What do Cays residents want in Cays Park?

KEY FINDINGS from the 2021 & 2023 Surveys

Kevin Reilly
11/1/2023

25% PLAN REVISIONS

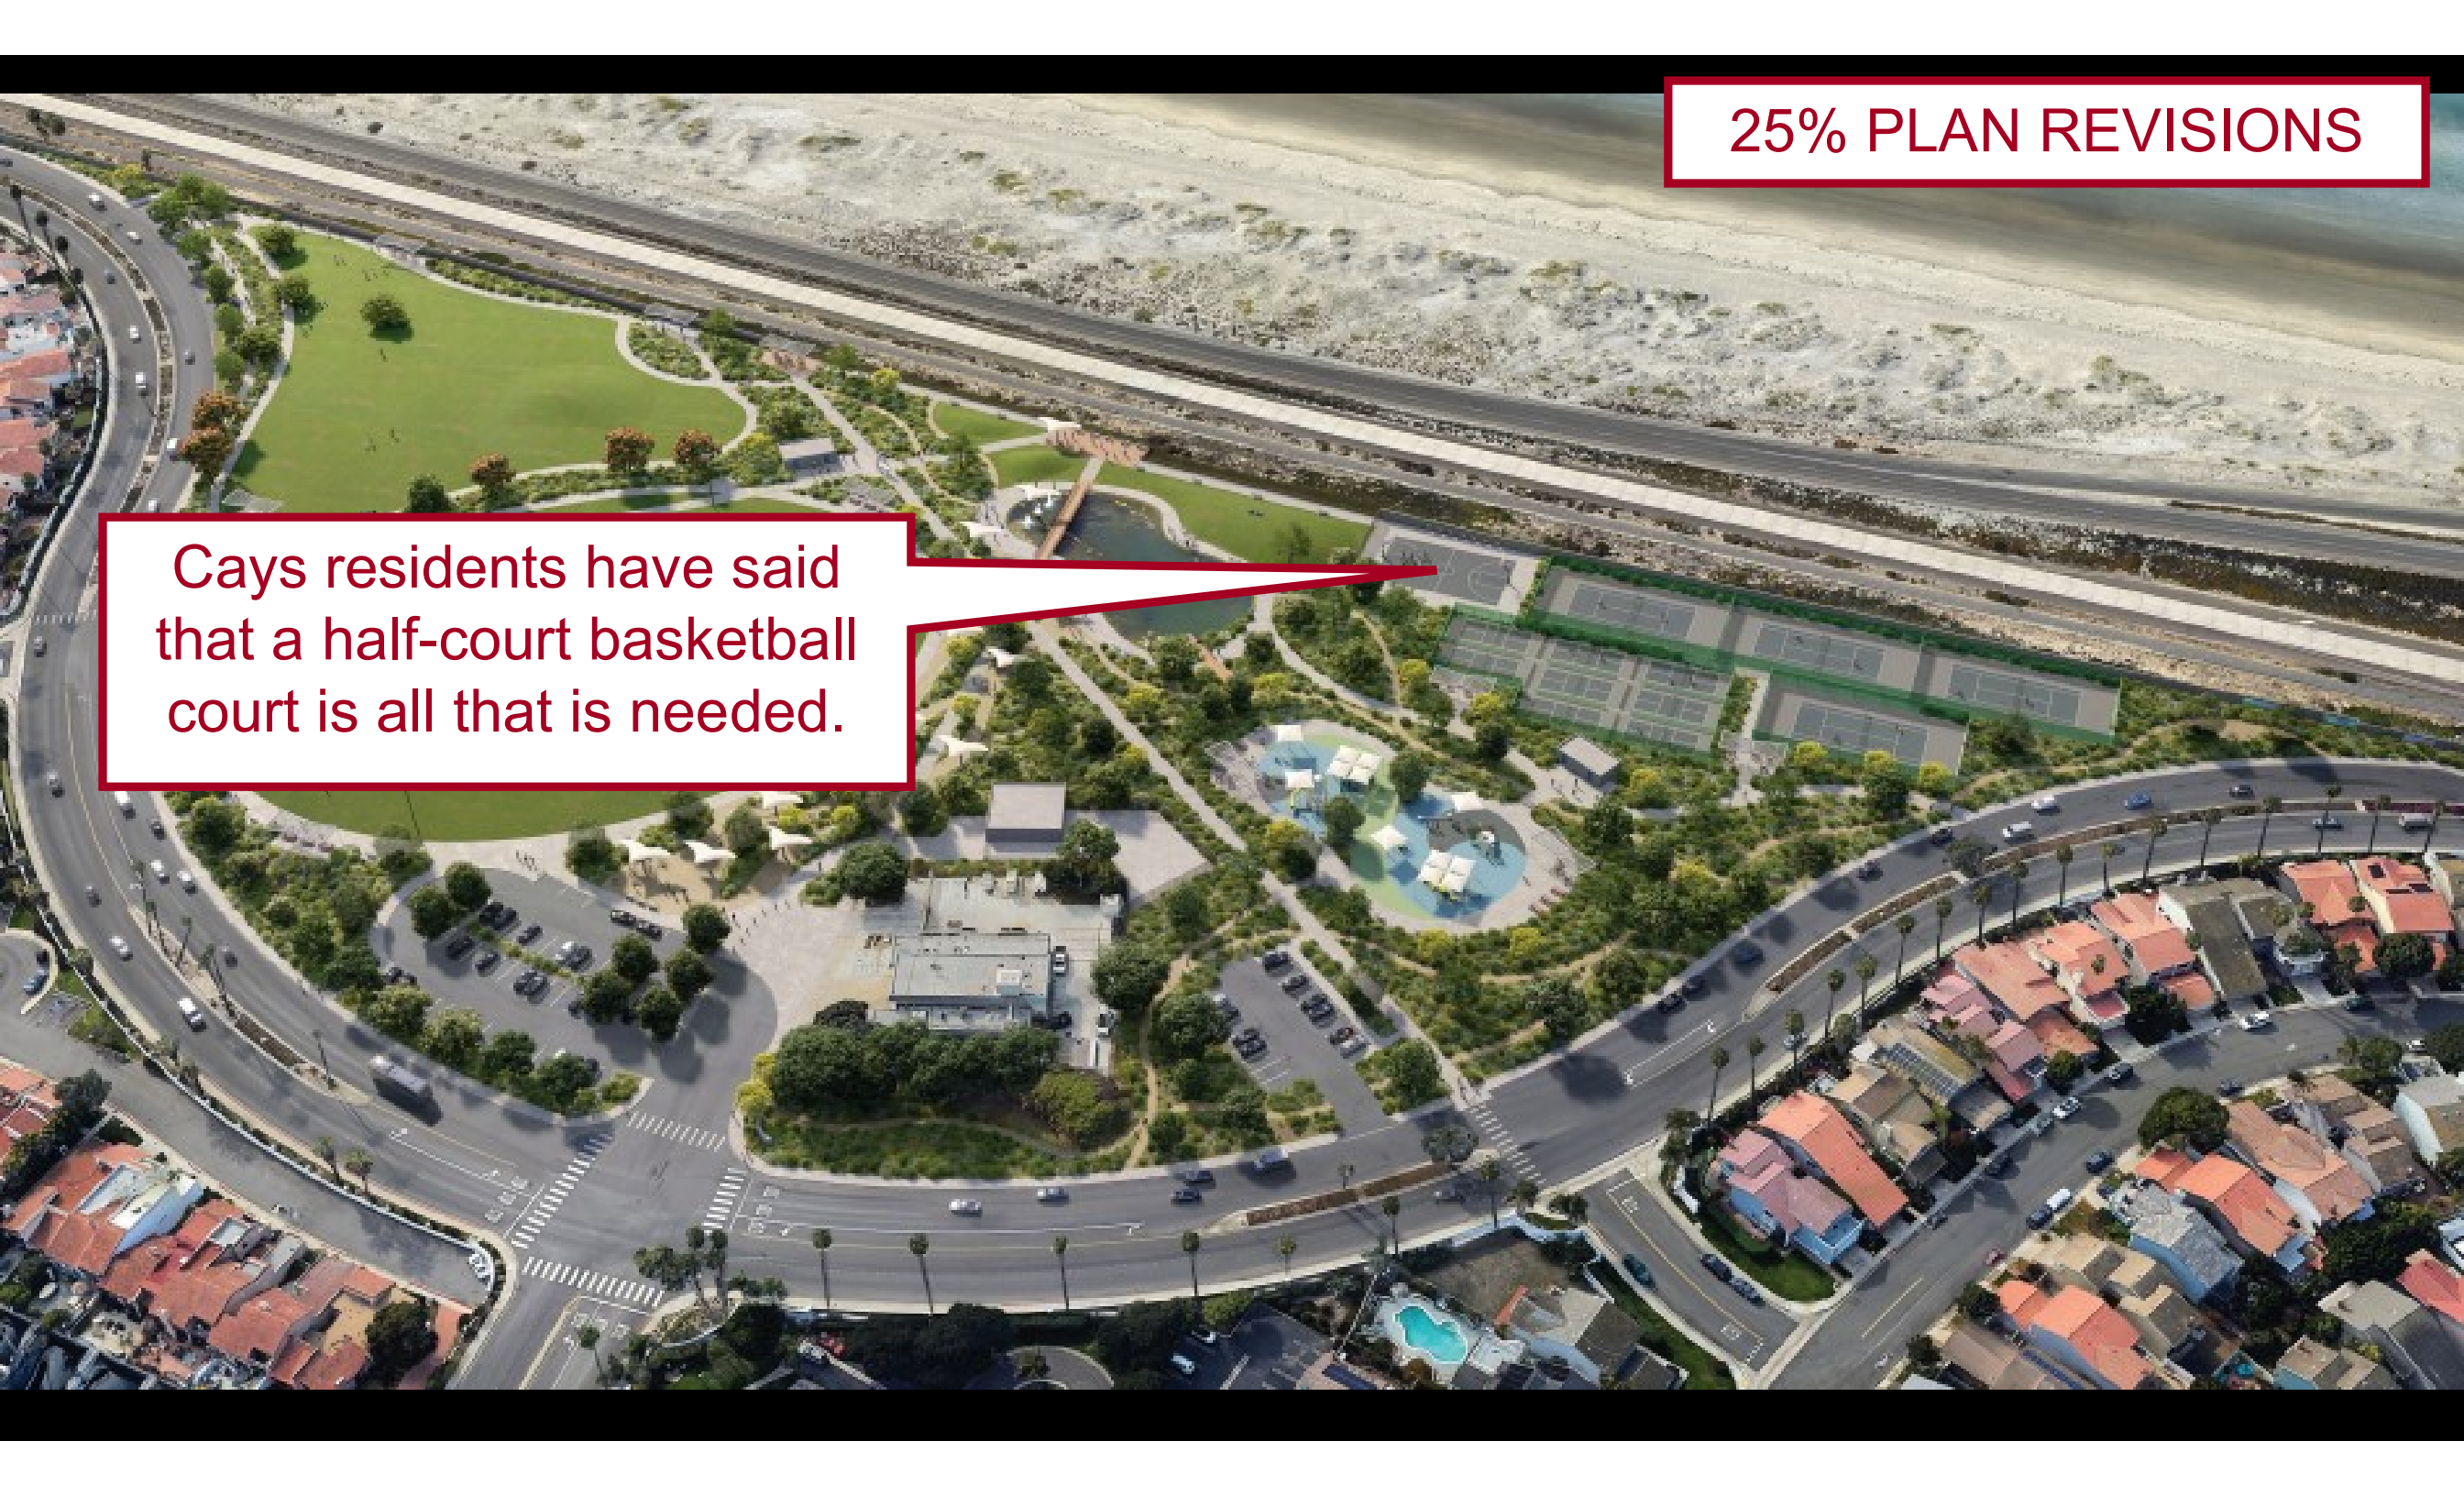
Cays residents do not want
the number of pickleball
and/or tennis courts
increased.

COMPROMISE SOLUTION

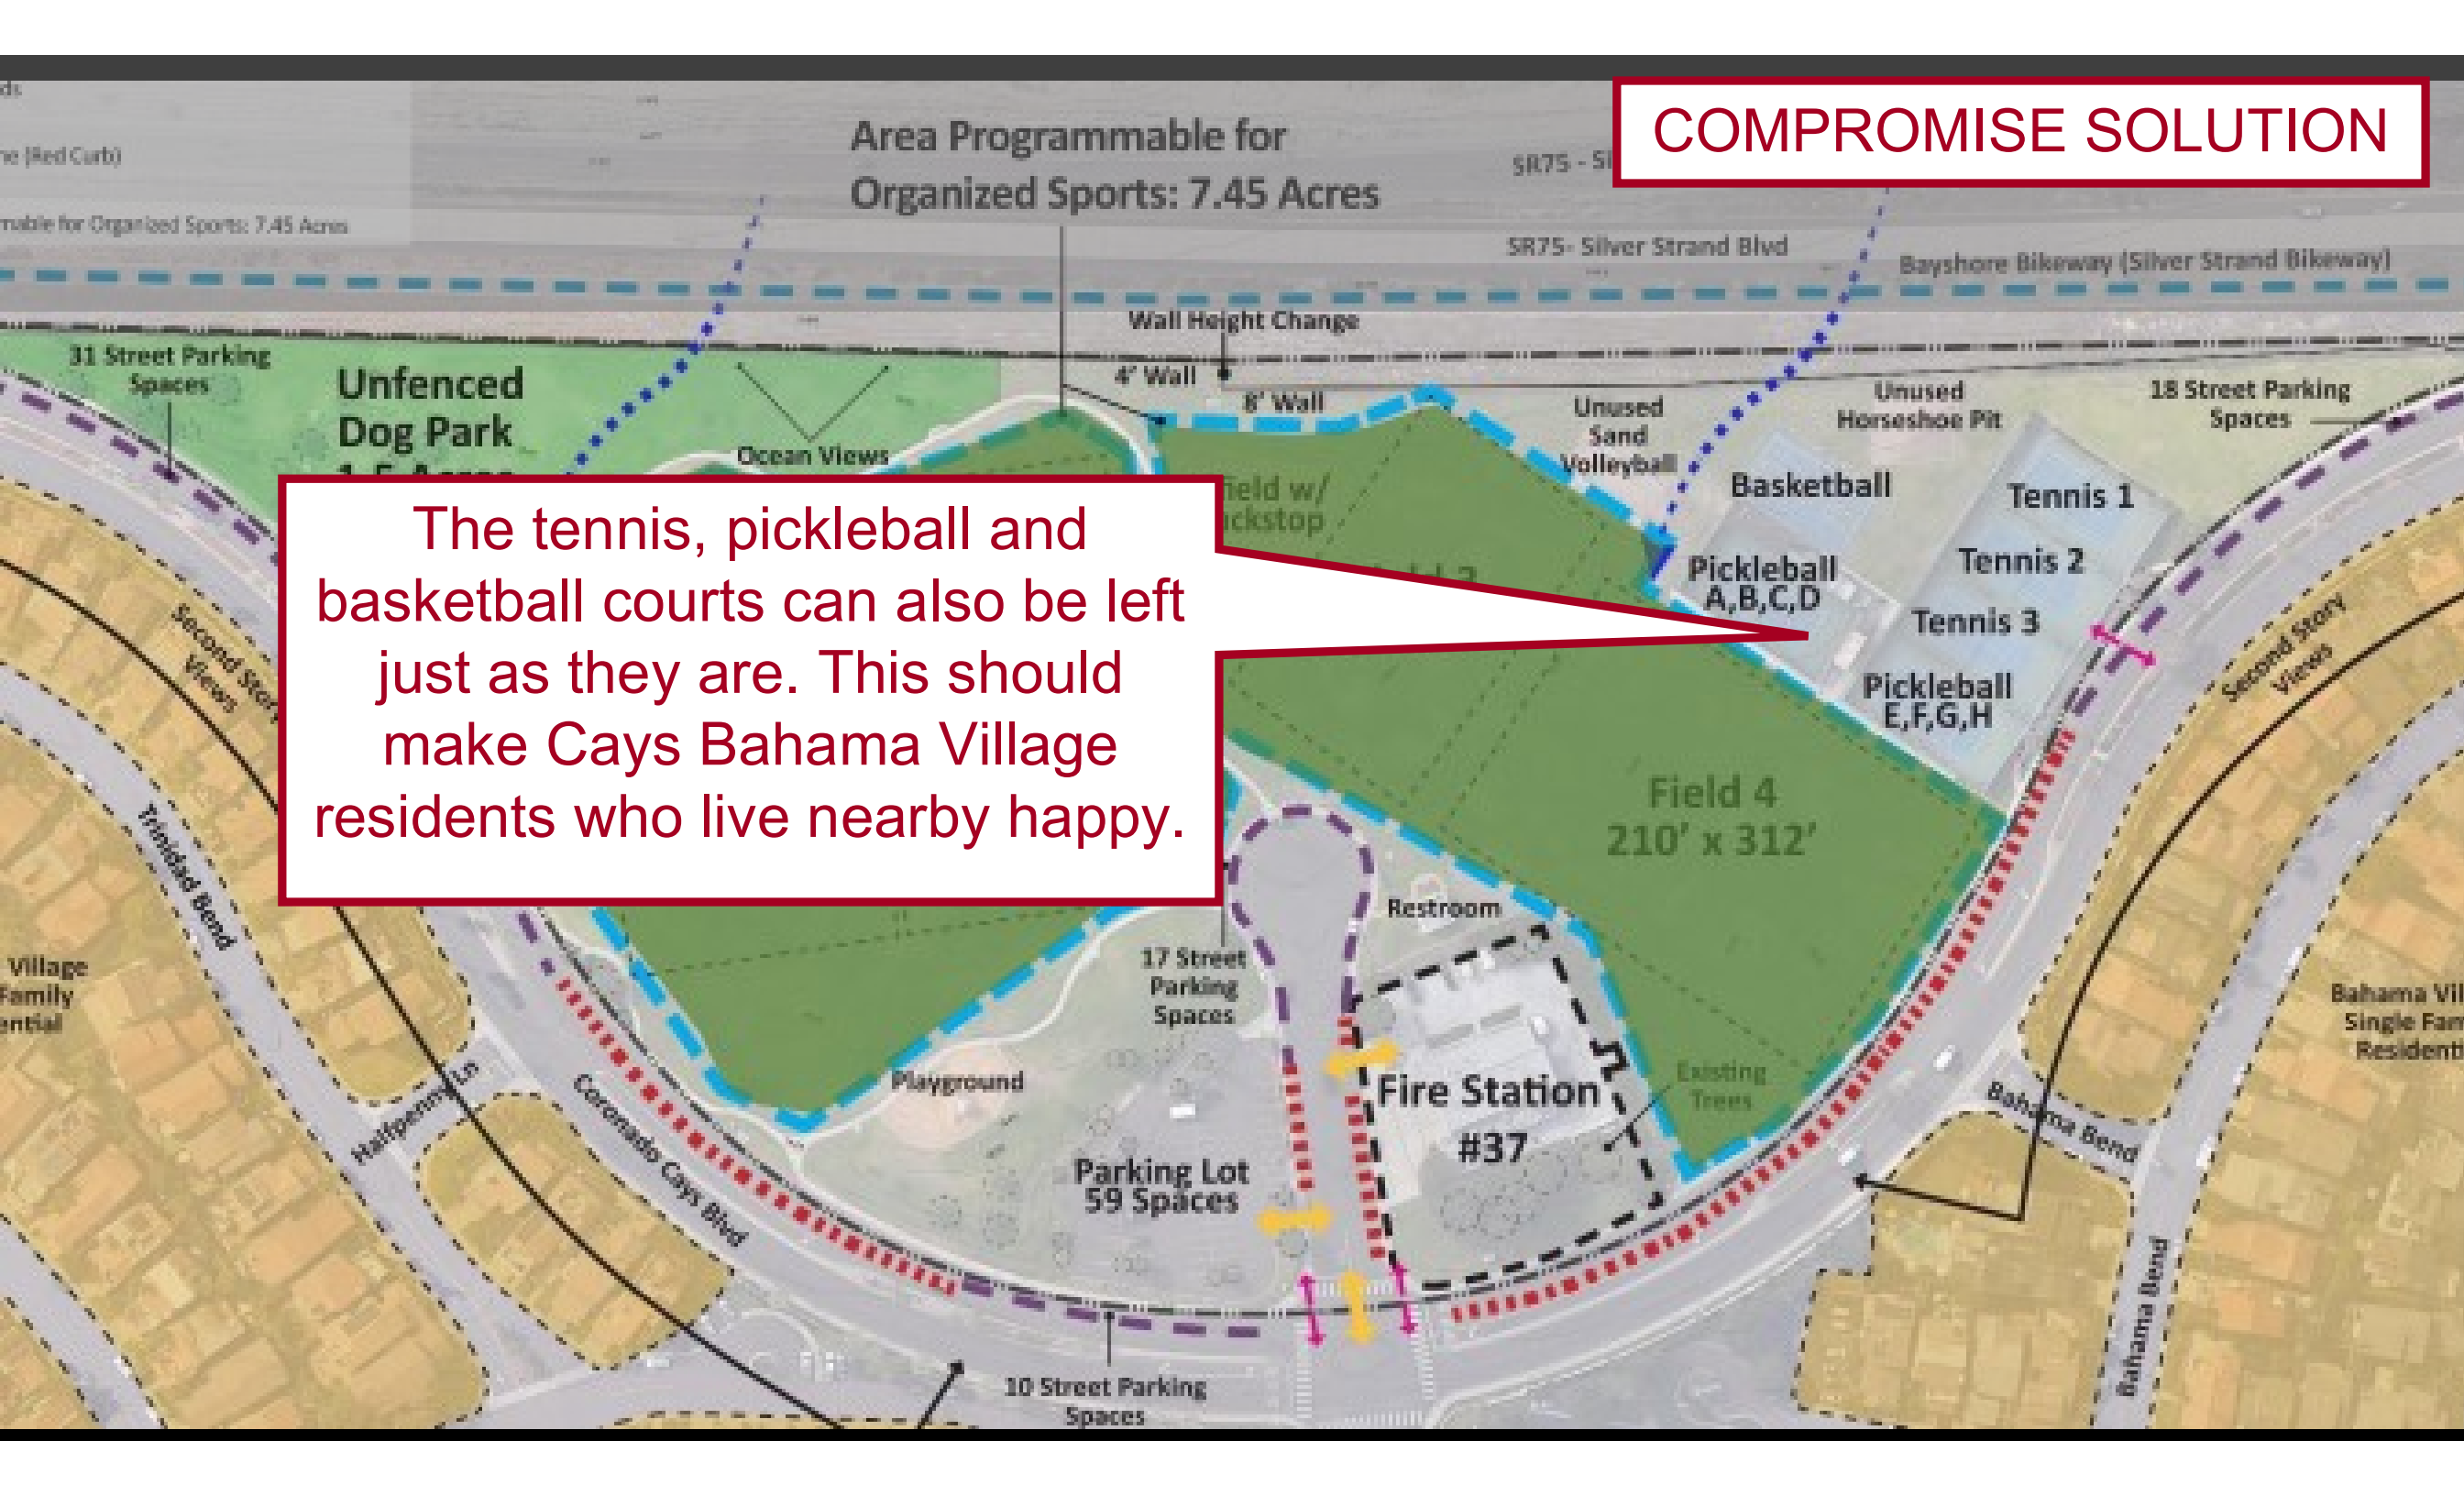
Although it is far more soccer than Cays residents want, one possible “compromise solution” is to remove the baseball backstop and dedicate Fields 3 and 4 just for the Coronado Futbol Club. This provides a large area just for soccer and involves a minimal change to the park.

COMPROMISE SOLUTION

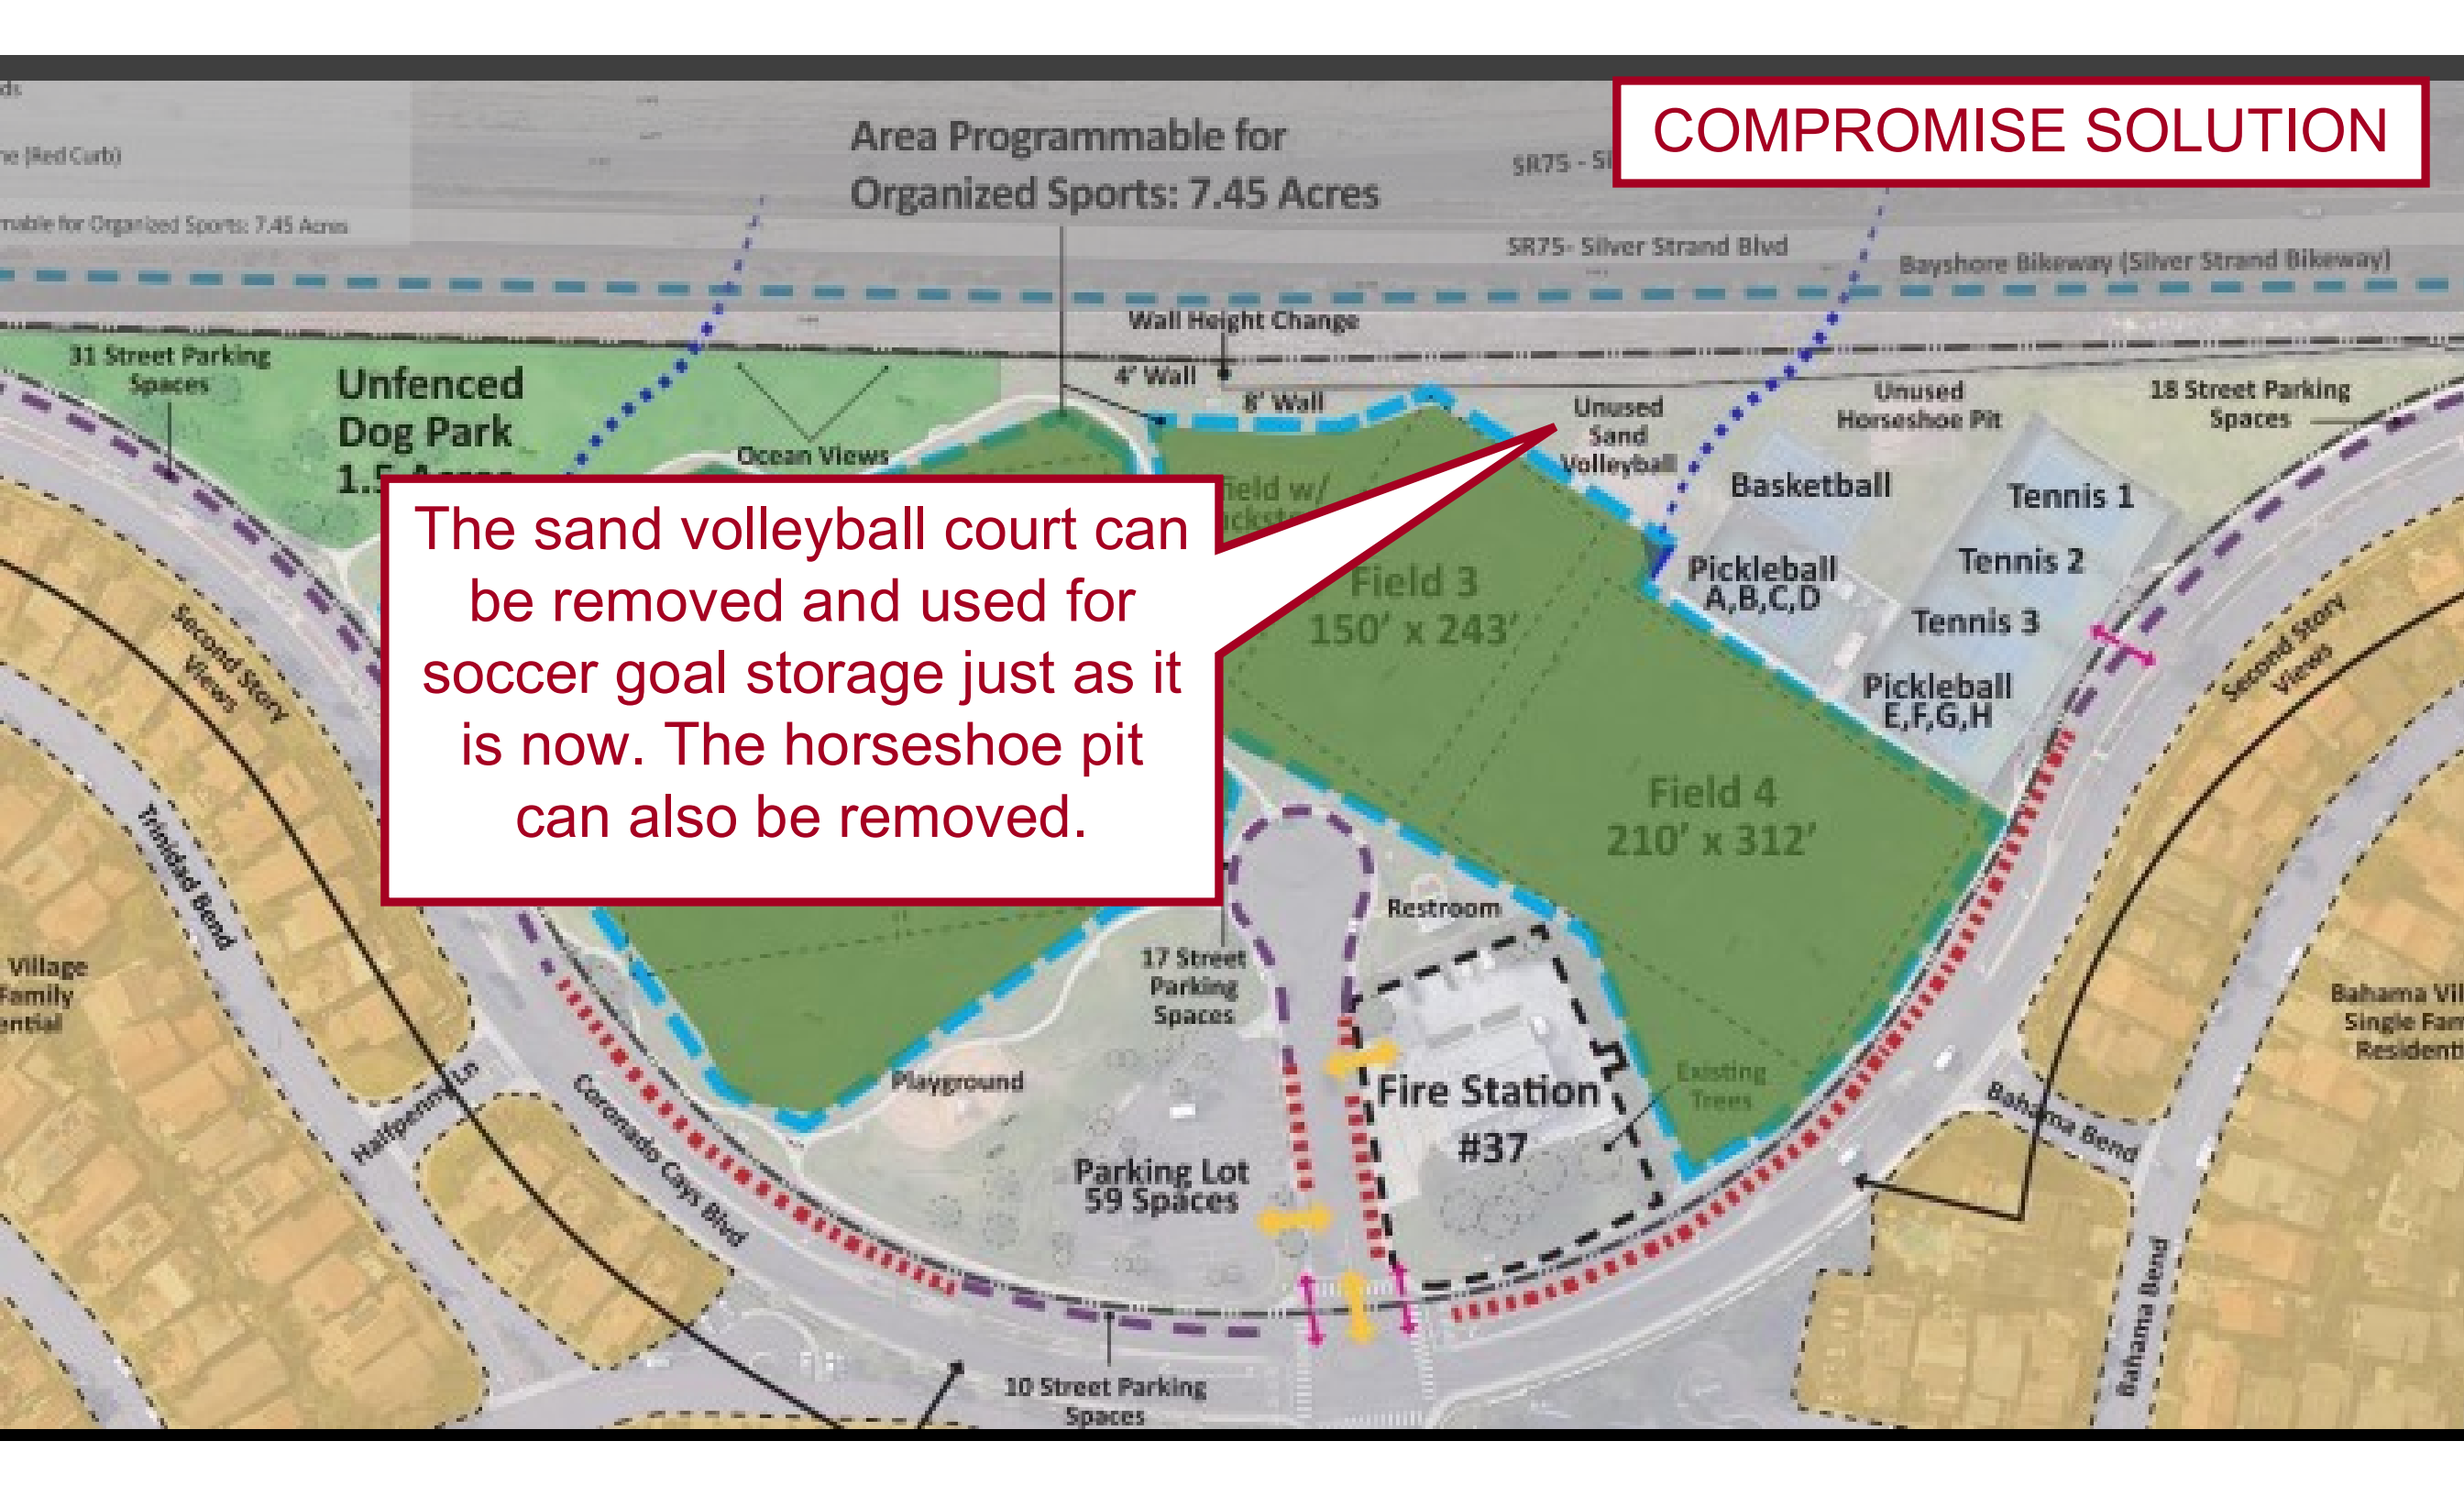
The sand volleyball court can be removed and used for soccer goal storage just as it is now. The horseshoe pit can also be removed.
